Subject: Interstate 4 from East of SR 15/600 (US 17/92) to ½ Mile East of SR 472 Value Engineering Study Recommendation Dispositions

FM: 408464-2

Interstate 4 from East of State Road 15/600 (US 17/92) to 1/2 Mile East of State Road 472

Value Engineering Study **Draft** Report

PROPOSED TYPICAL SECTION

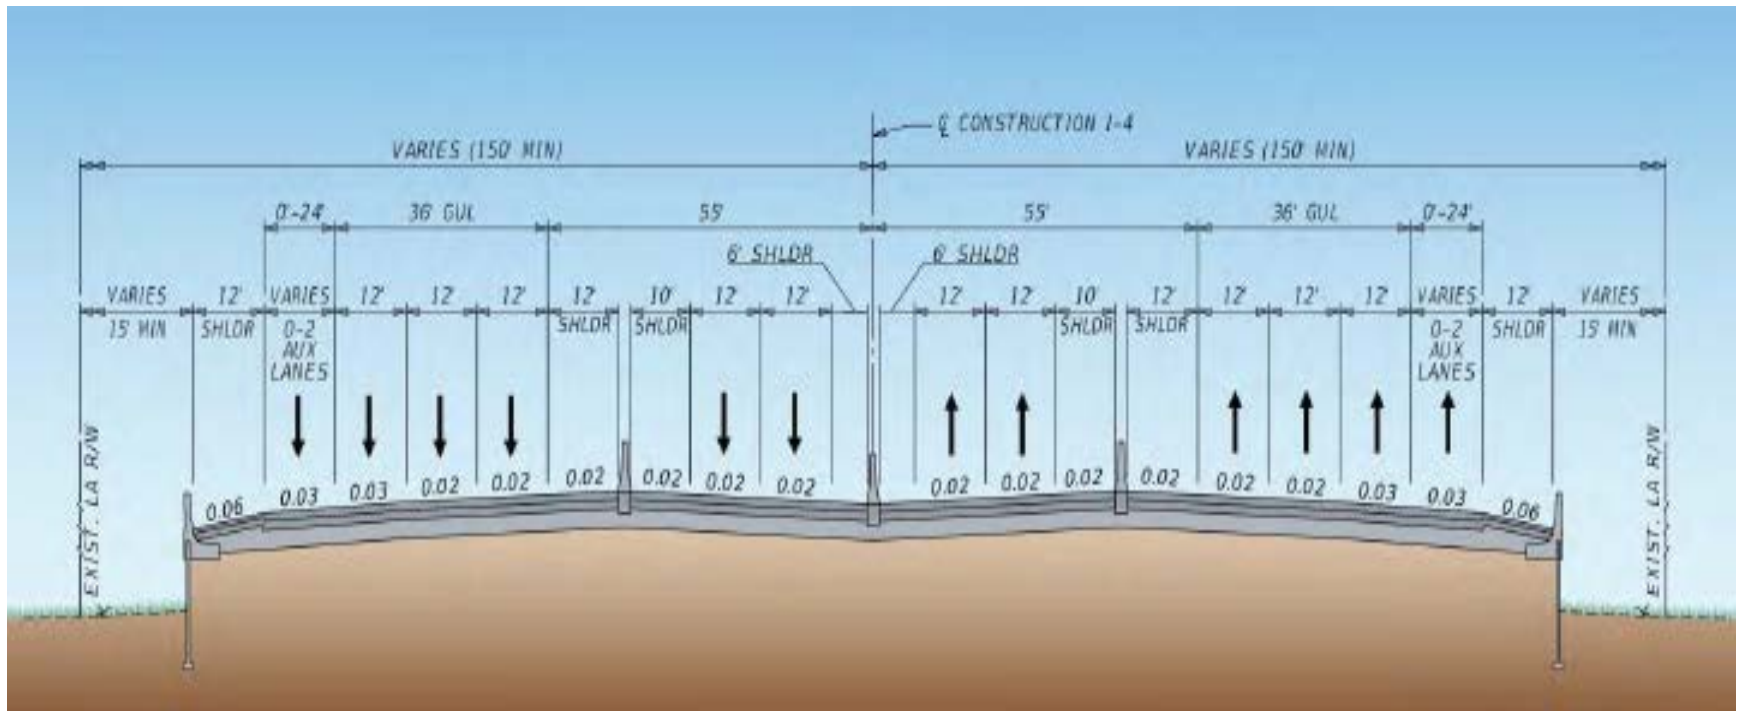
The PD&E Documents show the Typical Section with two express lanes in each direction with 10-ft. outside shoulders against barrier walls and a 6-ft. inside shoulder against the barrier wall using asphalt pavement.

RECOMMENDATION No. 3: Use concrete for the express lanes

Recommendation 3: Use concrete for the express lanes

Accepted. The use of concrete pavement will be considered for the construction of the express lanes.

RECOMMENDATION No. 7: Construct a box culvert under the new I-4 off ramp (that connects Eastbound Dirksen Dr.) to provide connectivity of the existing “Spring-to-Spring” multi-use trail

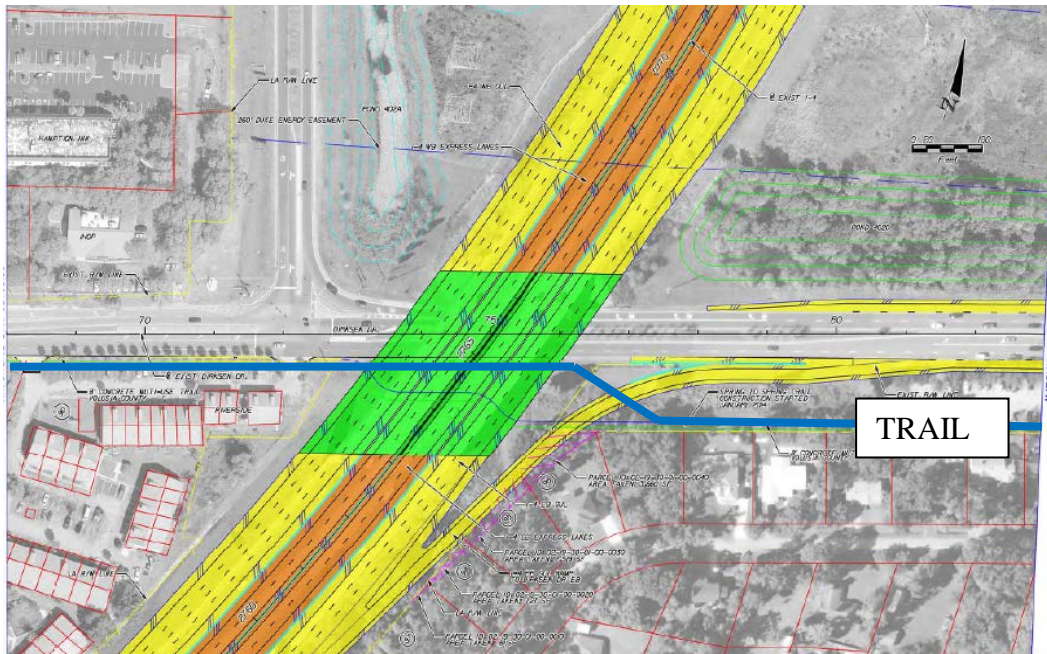
The PD&E Documents propose to span the existing “Spring to Spring” multi-use trail with a bridge structure. Currently the “Spring-to-Spring” trail runs east-west along the southern side of Dirksen Dr. under the existing I-4 bridge overpass. The I-4 bridge overpass will be replaced due to I-4 widening. Also, a new off ramp to Eastbound Dirksen Dr. will be added to the interchange which passes over the existing alignment of the multi-use trail. To provide continued connectivity for the multi-use trail the new off ramp will span the multi-use trail with a bridge structure.

Construct a box culvert, 10-ft. high by 19-ft. wide, under the new I-4 off ramp (that connects eastbound Dirksen Dr.) to provide continued connectivity to the existing “Spring-to-Spring” multi-use trail.

Recommendation 7: Construct a box culvert under the new I-4 off ramp (that connects Eastbound Dirksen Dr.) to provide connectivity of the existing “Spring-to-Spring” multi- use trail

Accepted. A concrete box culvert or prefabricated bridge type structure will be considered at the location of the new ramp.

RECOMMENDATION No. 10: Hold the North side right-of-way line on Saxon Boulevard and take only on the South side (Alternative 5)

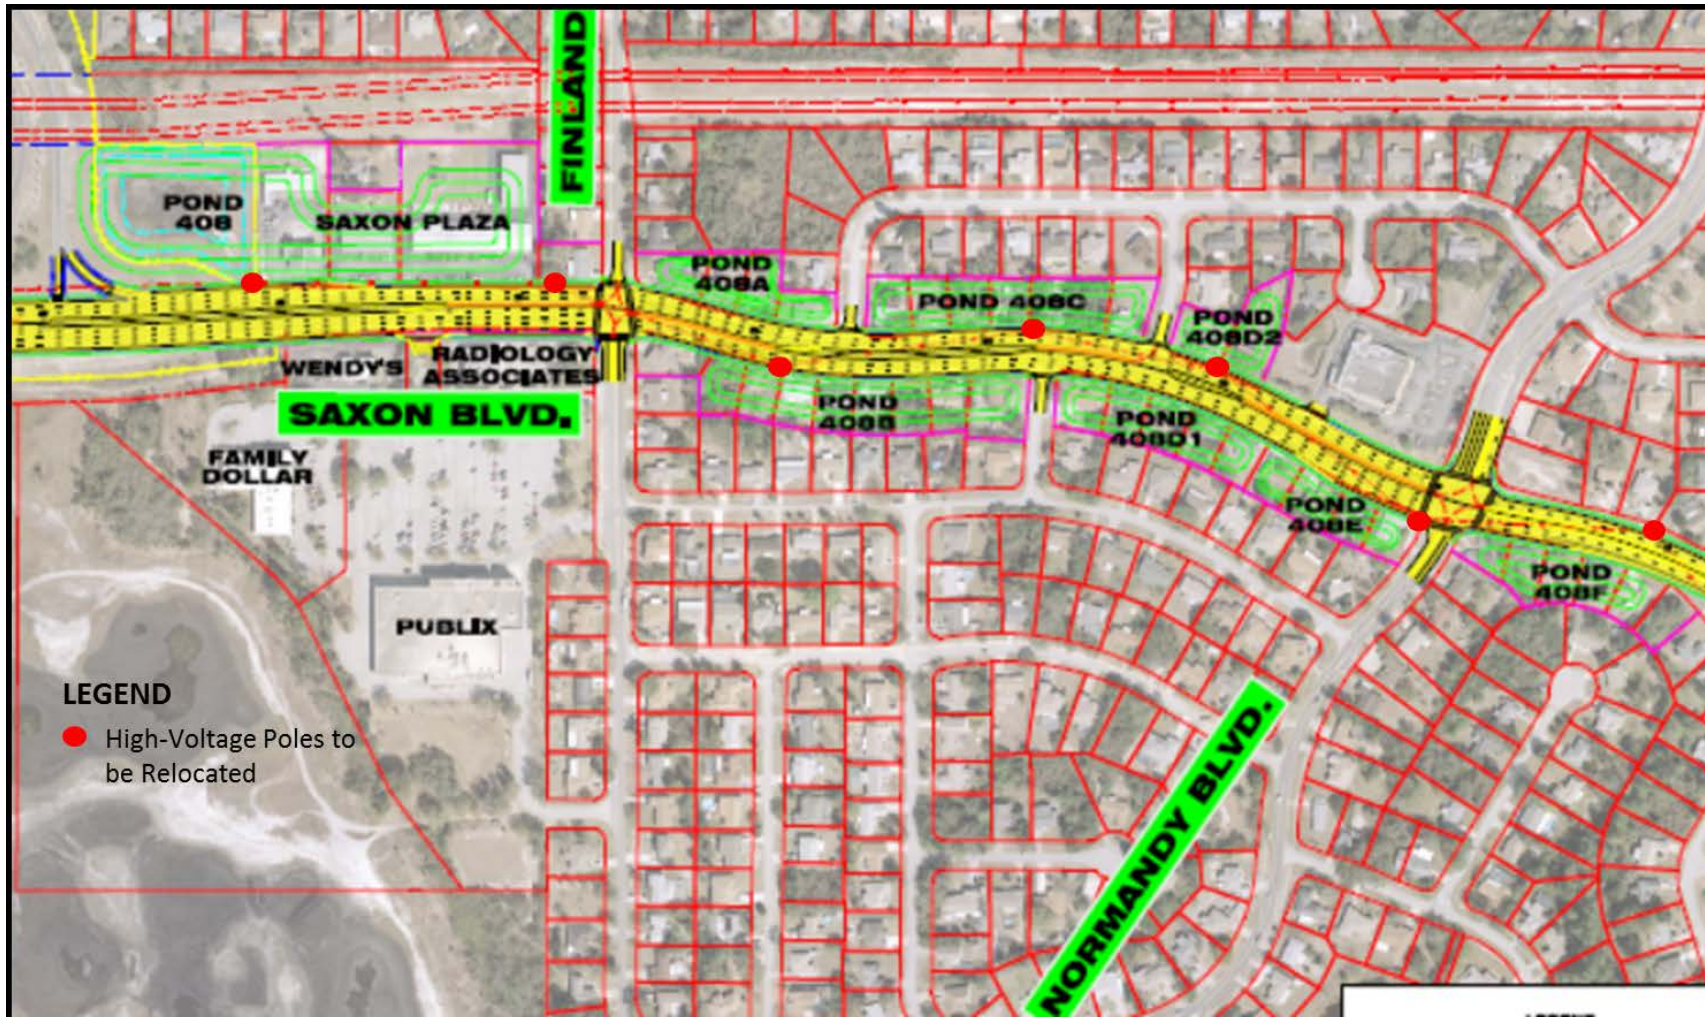
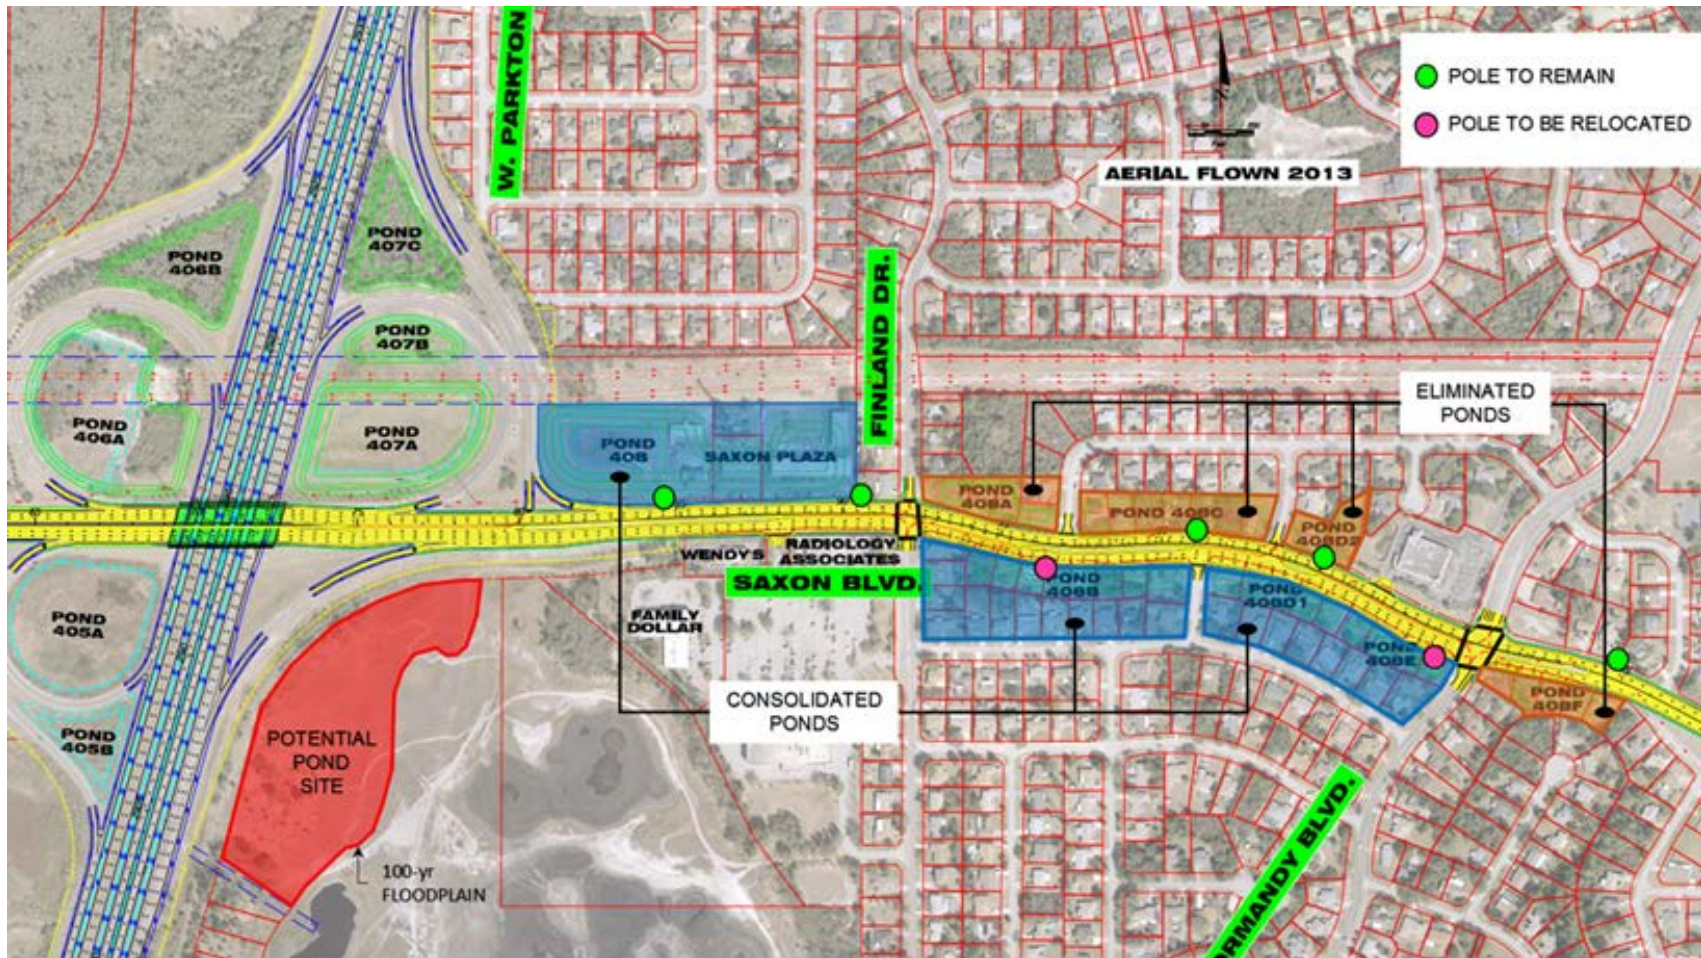
The PD&E Documents show right-of-way takings on the north and south sides of Saxon Boulevard from I-4 to east of Normandy Boulevard. The taking is for widening Saxon Boulevard outward from the centerline and also for ponds needed for the widening. The centerline widening requires the relocation of seven existing high voltage transmission poles.

Recommendation 10: Hold the North side right-of-way line on Saxon Boulevard and take only on the South side (Alternative 5)

Accepted. Alternative 5 will be the preferred alternative carried forward for Saxon between Finland and Normandy should this section of roadway require capacity improvements.

RECOMMENDATION No. 12: Construct a Diverging Diamond or Single Point Diamond Interchange instead of loops at SR 472

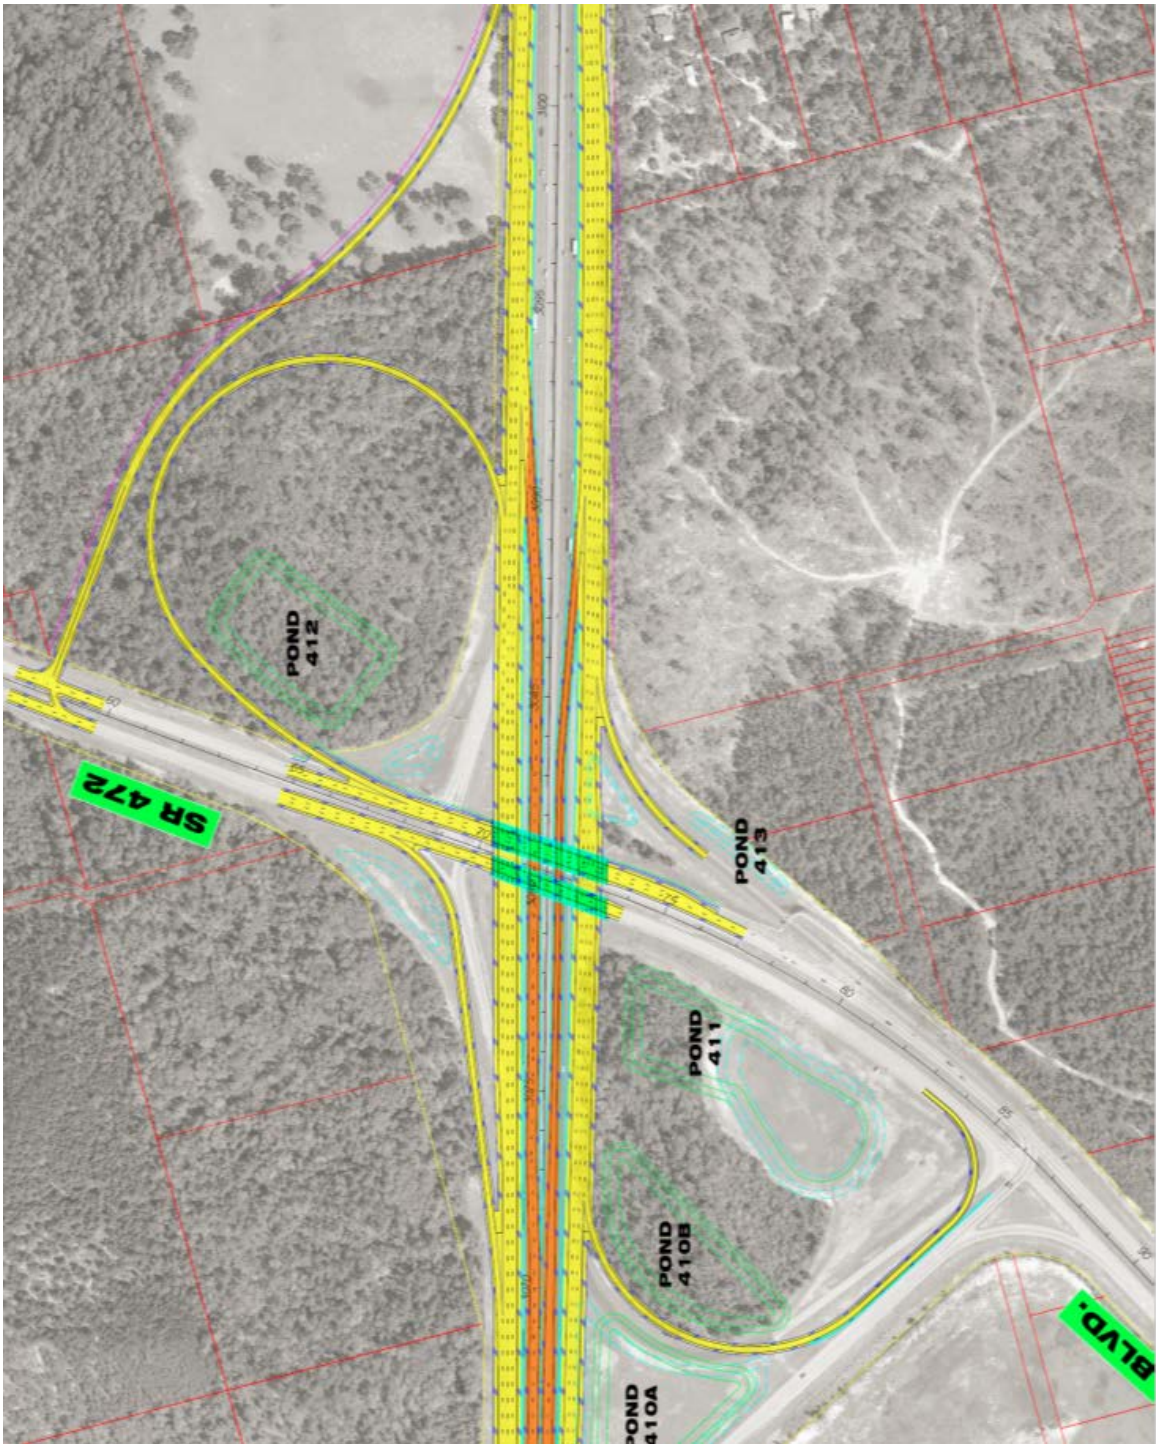
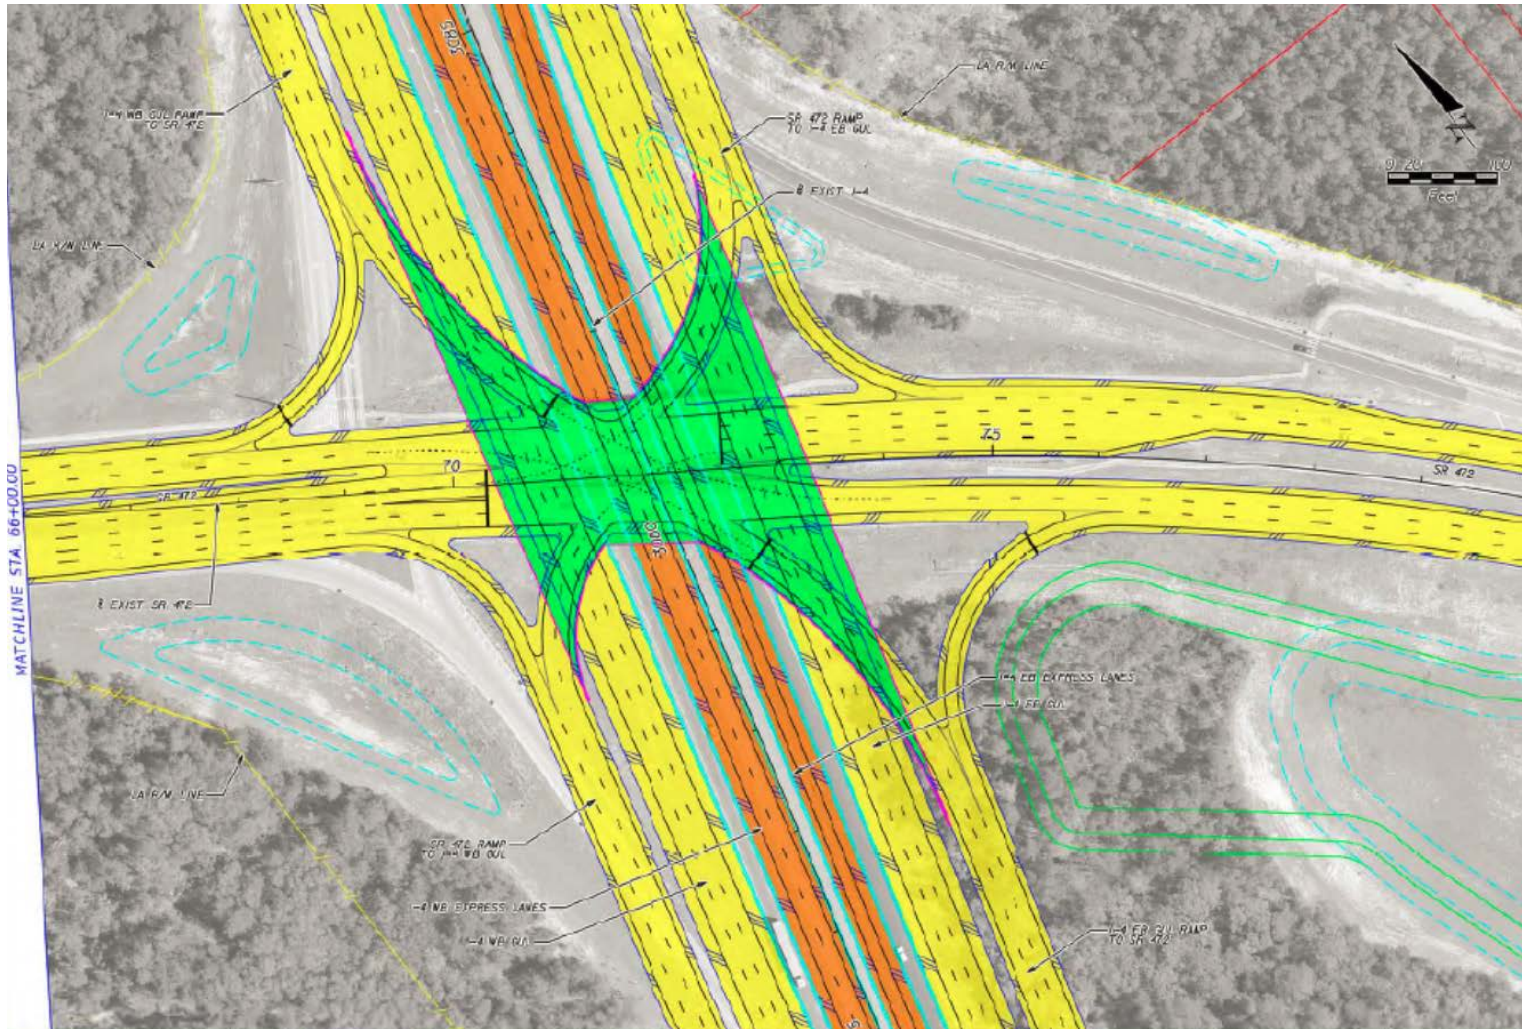
- Bridge size doubles and longer spans
- Increased cost
- More difficult constructability
- Added maintenance costs
- *Right of way acquisition costly at \$1,700,000*

Alt 1 construction cost est.:	\$15,600,000	(Loops and ramps)
Additional right of way	\$7,200,000	
Drainage credit	<u>-\$760,000</u>	
Total	\$22,000,000	
Alt 2 construction cost est.:	\$30,000,000	(DDI/SPDI)
Additional right of way	\$100,000	
Drainage credit	<u>-\$1,460,000</u>	
Total	\$28,600,000

Recommendation 12: Construct a Diverging Diamond or a Single Point Diamond Interchange instead of loops on SR 472

Accepted. A SPDI was evaluated, and it was determined that it functioned better than a loop ramp, and required much less right of way. Since a SPDI works at this location, a DDI is also being evaluated to determine if this concept would provide improved operations over a SPDI.
